# UNITED STATES PATENT AND TRADEMARK OFFICE

10/530,077

<b>Office Action Summary</b>	<b>Application No.</b> 10/530,077	<b>Applicant(s)</b> BORTOLI ET AL.	
	<b>Examiner</b> DNYANESH KASTURE	<b>Art Unit</b> 4147

## **DETAILED ACTION**

**Fig. 1** (PRIOR ART)

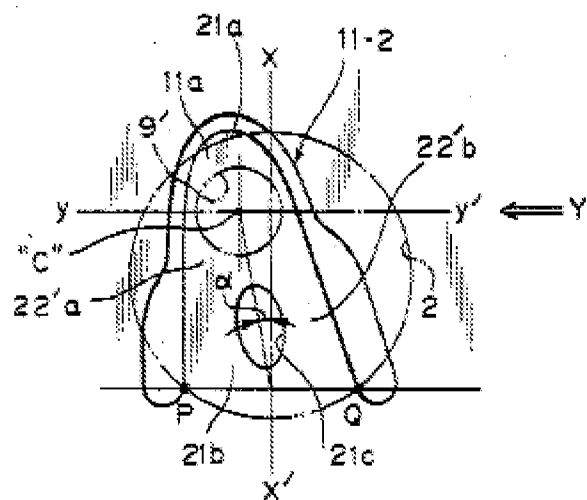
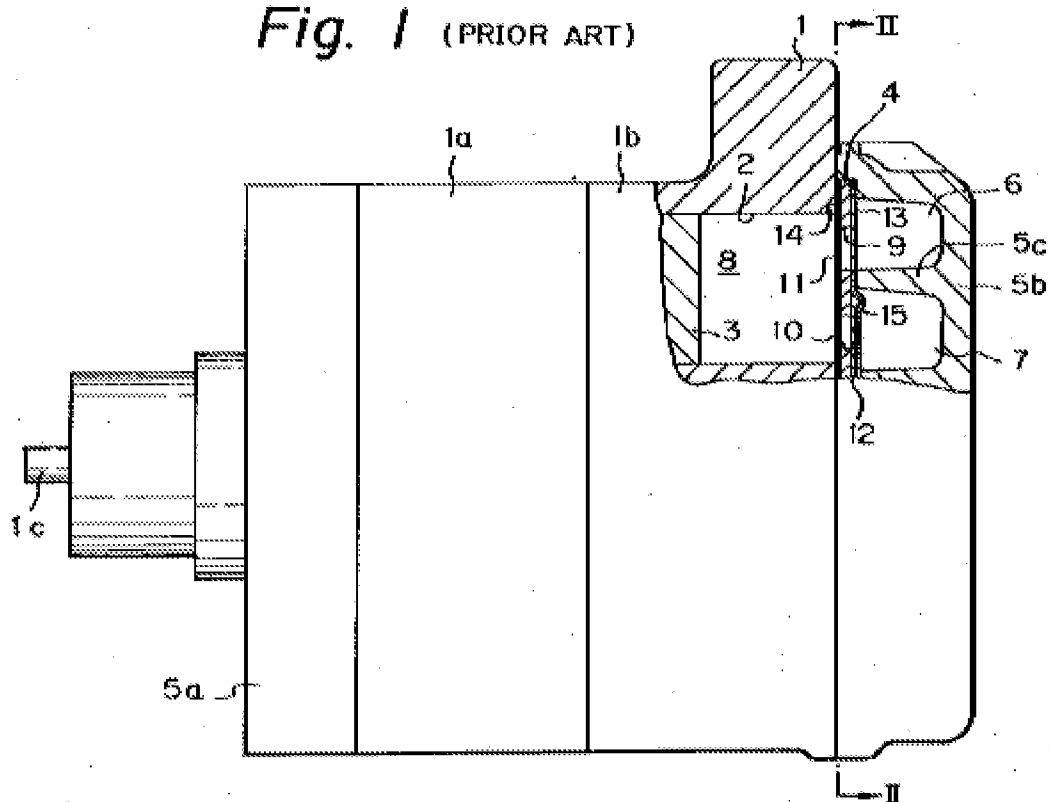
11. In Re claim 1, with reference to Figures 5A and Figure 1, Ikeda et al discloses a suction reed valve described as:

- whose end is closed by a valve plate (4)
- a flexible vane (11) which is disclosed as suction valve disc made of an elastic steel plate (column 4, line 34)
- a fixation portion in the vane defined by the arc segment around points connecting points P and Q
- a bending median portion defined by a section of the valve between tangential lines at the tips of the ellipse parallel to a line drawn through points P and Q
- a discharge orifice (10)
- a suction orifice (9)
- a sealing end portion defined by a section around line y-y' of the valve beyond the elliptical section.
- the distance between the external and internal edge diminishes from a maximum near the fixed end P-Q to a minimum at the half way point of the elliptical opening.
- The outline of the vane from point P to point Q along its edge presents a "U" shape.

12. In Re claim 5, Ikeda et al discloses an elliptical shaped opening where the slope of the internal edge inherently decreases more rapidly starting at the apex of the ellipse. As a result the thickness L also decreases more rapidly close to the apex of the ellipse.

13. In Re claim 8, Ikeda et al discloses a gap that is larger at the fixed end of the vane than at the apex. Note that in accordance to MPEP 2113, the method of forming the flexible vane (by cutting from the support blade) is not germane to the issue of patentability of the device itself.

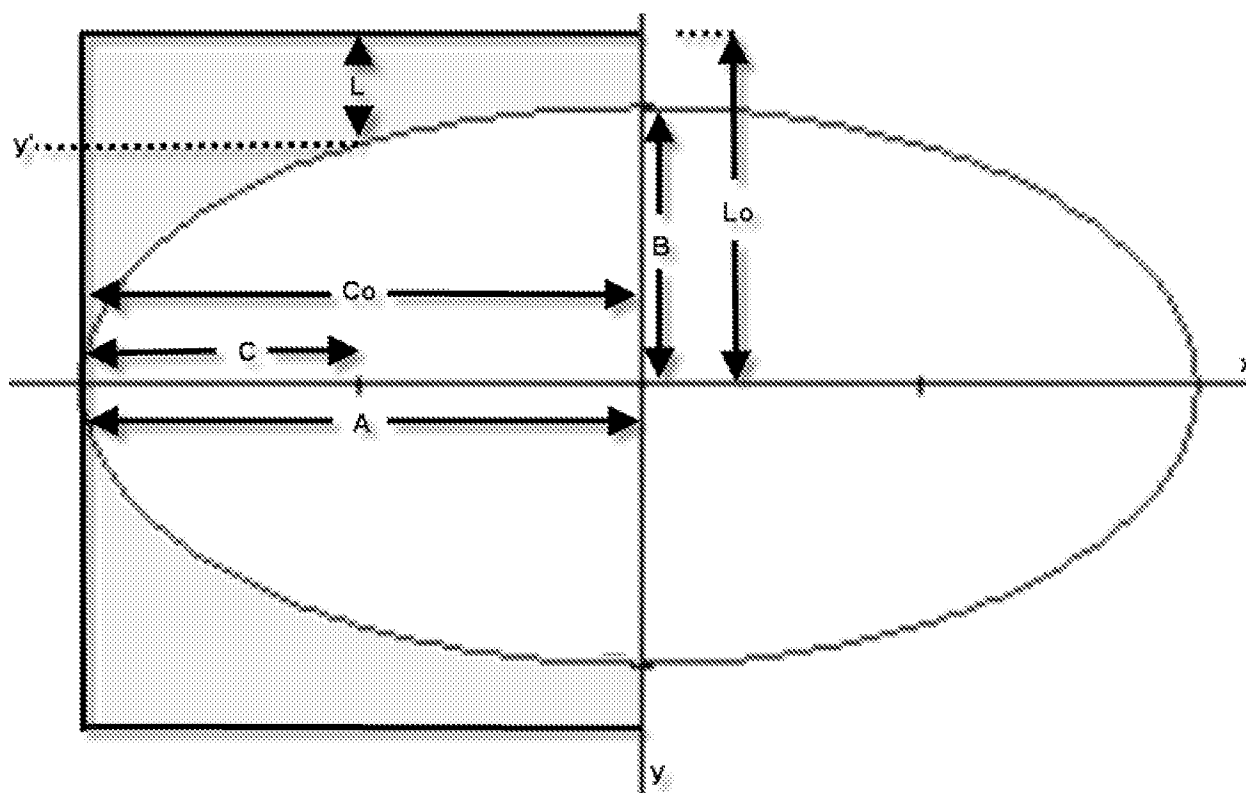
15. In Re claim 7, the embodiment that applicant discloses in the specification by giving numeric values to the polynomial equation may infringe on prior art in specific areas of the high bend region. For example, a specific ratio of width of the elliptical opening to the total width ( $B/L_o = 66.48\%$ ) is inherently used by Schulze in Column 4, Line 58 and 59 (which enumerates the  $OD = 2.449$ ,  $ID = 1.628$  and therefore the ratio of  $ID/OD = 1.628/2.449 = 0.66476$ ).

16. The above figure is a depiction of a high bend region formed by an area between the rectangle and the elliptical contour. To simplify calculation, the horizontal edges of the rectangle form the edges of the valve. Applicant discloses the width of the high bend region for one embodiment specifying a set of values for "a", "b", "c" and "d". Applicant also discloses that a deviation of 20 % is also adequate. Based on the values of these constants, a sample calculation was made for the value of  $L/L_o$  corresponding to the midpoint of the high bend region ( $C/Co = 0.5$ ) and associated  $\pm 20\%$  tolerance:

When  $C/Co = 0.5$ ,  $L/L_o = 0.432063$  (tolerance within 0.34565 and 0.518475)

Following is a standard equation of an ellipse:

$$y' = B * \sqrt{1 - (x^2 / A^2)}$$

Plugging in  $x = A/2$  for the midpoint of the high bend region, and solving for  $y'$ , we have:

$$y' = ((\sqrt{3})/2) * B$$

Since  $L = L_0 - y'$  from the figure, we can substitute for  $y'$  from the above equation to get:

$$L = L_0 - ((\sqrt{3})/2) * B$$

Substituting  $L = L_0 * 0.432063$  from the calculation on the applicant's data, we have:

$$L_0 * 0.432063 = L_0 - ((\sqrt{3})/2) * B$$

Simplifying the above equation and solving for  $B/L_0$  yields:

$$B/L_0 = 0.655797 = 65.58 \%$$

This is almost the same as the 66.48 % as inherently used by Schulze. A slightly different value of  $L/L_0$ , that is well within the 20 % tolerance, would have yielded the exact same percentage as Schulze.

***FIG. 3***

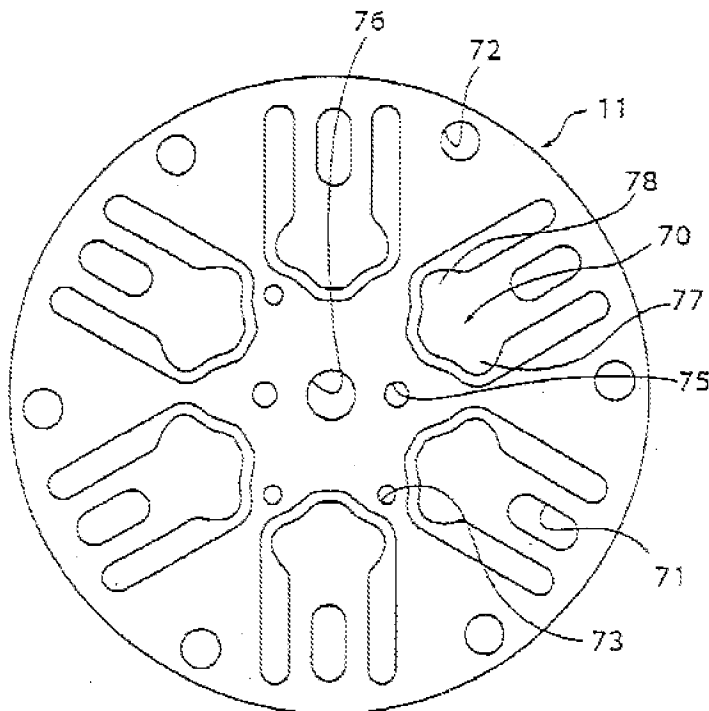
19. In Re claim 2, Ikeda et al discloses the increasing width of the median opening by virtue of the elliptical shape, and it also discloses the diminishing total width of the flexible vane up to the mid point of the elliptical opening however, it does not disclose the progressive increase thereafter.

20. Nevertheless Une et al discloses, with reference to Figure 3 depicted above, an increase in the total width in the top section of the vane (70).

21. It would have been obvious to a person having ordinary skill at the time of the invention to modify the vane disclosed in Ikeda et al to have a larger sealing end portion as taught by Une et al for the following reason:

22. If the size of the suction port is larger than the width of the vane, the sealing end section of the vane would have to be made larger to completely cover the suction port.

In addition, it would be logical to increase the width of the vane from the half way point of the elliptical opening to incorporate the increased size of the sealing end portion because the thickness L inherently starts to increase at this point. This further insures that there is a smooth outer edge to the vane, which relieves stresses related to sharp corners.

**FIG.6**

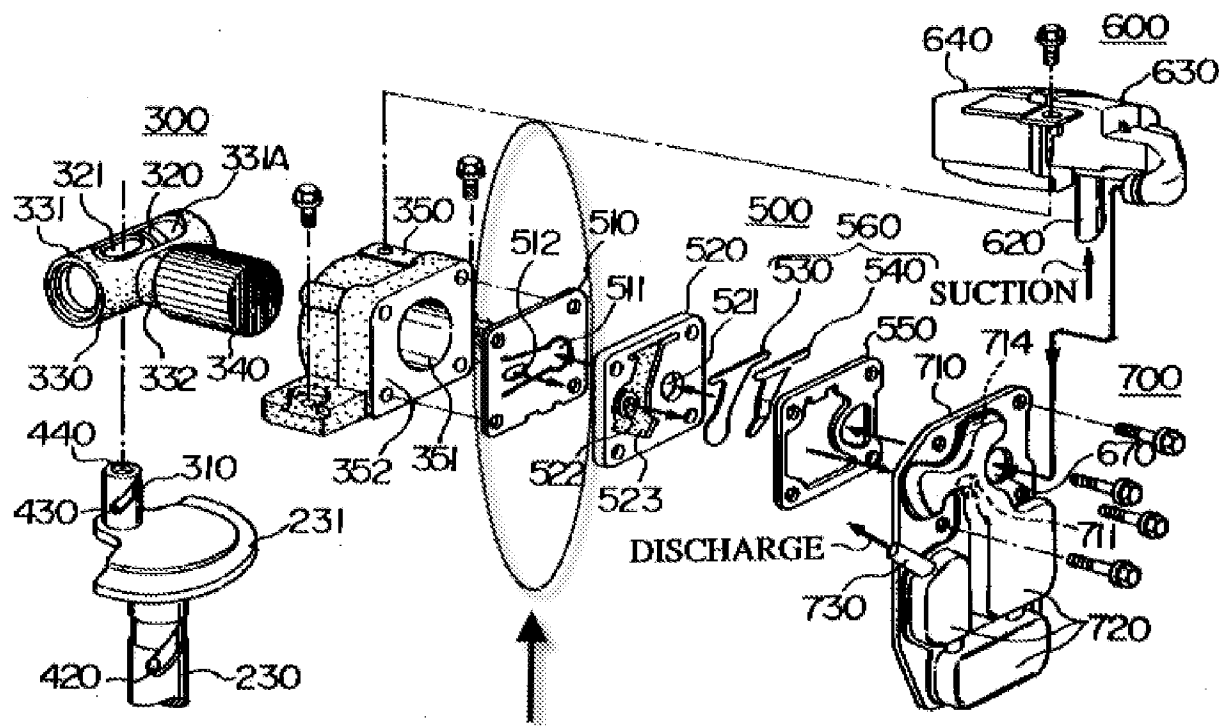
25. In Re claim 2, Ikeda et al discloses the increasing width of the median opening by virtue of the elliptical shape, and it also discloses the diminishing total width of the flexible vane up to the mid point of the elliptical opening however, it does not disclose the progressive increase thereafter.

26. Nevertheless Hirano et al discloses, with reference to Figure 6 depicted above, an increase in the total width in the top section of the vane (511).

27. It would have been obvious to a person having ordinary skill at the time of the invention to modify the vane disclosed in Ikeda et al to have a larger sealing end portion as taught by Hirano et al for the following reason:

28. If the size of the suction port is larger than the width of the vane, the sealing end section of the vane would have to be made larger to completely cover the suction port. In addition, it would be logical to increase the width of the vane from the half way point of the elliptical opening to incorporate the increased size of the sealing end portion because the thickness L inherently starts to increase at this point. This further insures that there is a smooth outer edge to the vane, which relieves stresses related to sharp corners.
